Facilities Access Compliance Survey Report for the Santa Clara Valley Open Space Authority

Santa Clara Valley Open Space Access Compliance Survey Report

Facility: **Administrative Office**

Santa Clara Valley
April 2023
SSA Project #: 21058

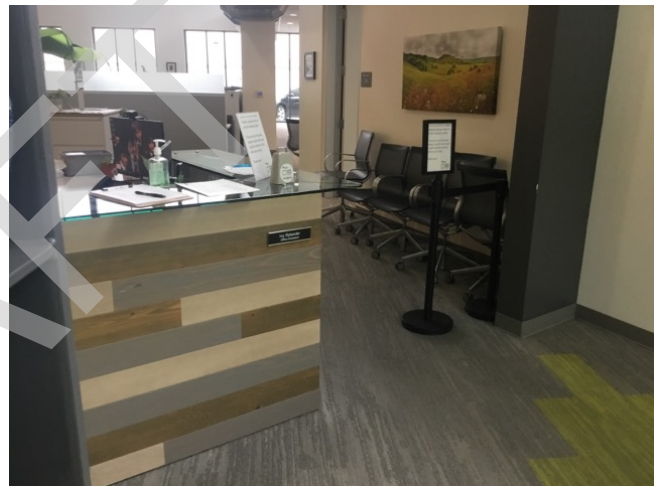
Provide cane-detectable railing to mark area of low clearance.

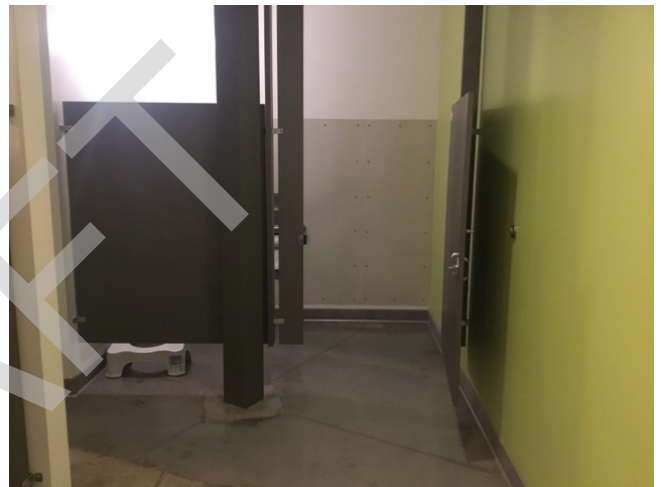
- 2454 • *As-Built Description:*
Toilet paper dispenser less than 15" (CA: 19") or more than 48" above floor or not within 7" to 9" from front of water closet (Note: CA pre-2010 is allowed within 12" from front of water closet).
- *As-Built:* **13" to the center of the entire steel dispenser enclosure. 17" to the centerline of the toilet paper rolls.**
- *Proposed Solution:*
Relocate or provide new toilet paper dispenser.

Stall Door

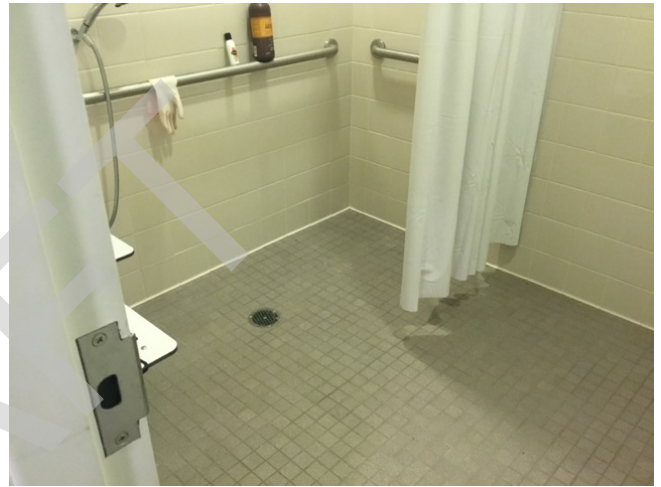
2479	<ul style="list-style-type: none"> As-Built Description: Stall door to accessible compartment not self closing. Proposed Solution: Adjust closer. 	PCODE WB05B ADAAG 91 4.22.4 ADA 2010 604.8.1.2 CBC 2007 1115B.3.1.4.4 CBC 2019 11B-604.8.1.2	1	JOB	\$75	\$75
						Priority 2 Severity 3

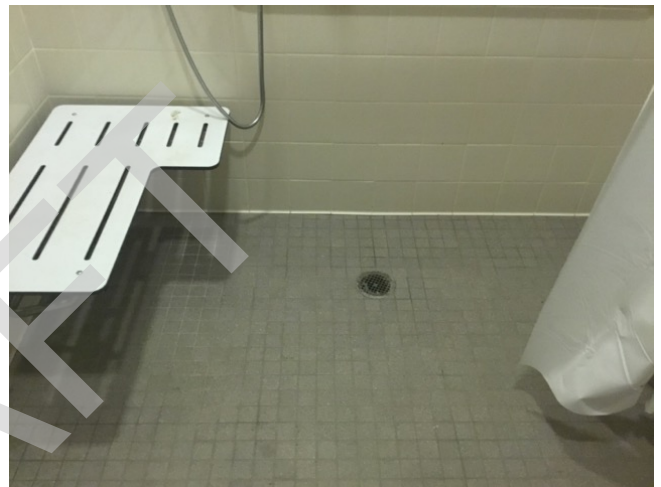
Signage						
2484	<ul style="list-style-type: none"> As-Built Description: Signs containing tactile characters is not located so that a clear floor space of 18" min x 18" min., centered on the tactile characters, is provided beyond the arc of any door swing between the closed position and 45 degree open position. As-Built: 4.5" to the wall. Proposed Solution: Relocate compliant signage on latch side of door located at compliant height with a clear floor space. 	PCODE SA07B ADA 2010 703.4.2 CBC 2019 11B-703.4.2	1	JOB	\$150	\$150
						Priority 2 Severity 4

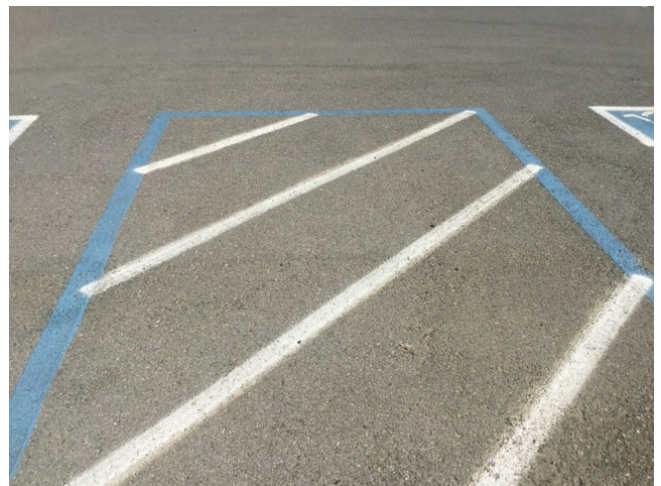
2281	<ul style="list-style-type: none"> As-Built Description: The words "NO PARKING" not painted on the ground within loading and unloading access aisle (12" min high white letters), located so that it is visible to traffic enforcement officials (required in CA only). Proposed Solution: Provide the words "NO PARKING" in each access aisle, painted in 12" high letters, when altering area. 	PCODE EA04D CBC 2007 1129B.3.1 CBC 2019 11B-502.3.3	1	JOB	\$300	\$300
					Priority	3
					Severity	4

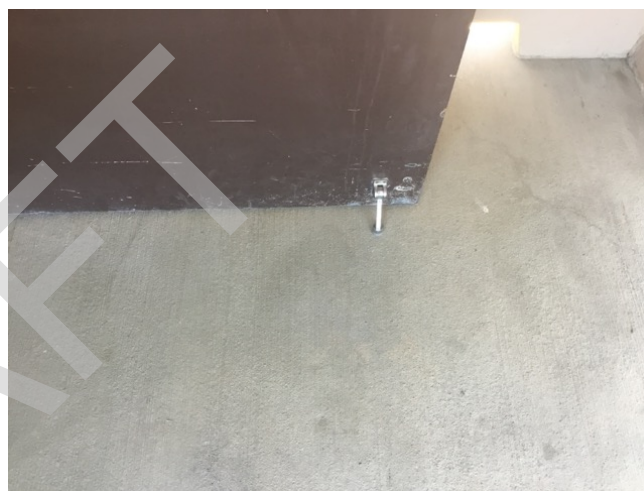
Signage						
2283	<ul style="list-style-type: none"> As-Built Description: Entrance to toilet or bathing facility not identified with ADAAG compliant signage. As-Built: Braille.25" from tactile characters. Braille and dots are nearly touching each other. Proposed Solution: Provide ADA compliant sign mounted at 48" min. above to baseline of the lowest Braille cells and 60" max. to baseline of the highest line of raised characters on nearest adjacent wall, on latch side of a single door (located not to cause a Braille reader to stand within the door swing). 	PCODE SA11A ADAAG 91 4.1.3(16)(a) ADA 2010 216.8 CBC 2019 11B-216.8	1	JOB	\$270	\$270
					Priority	2
					Severity	3
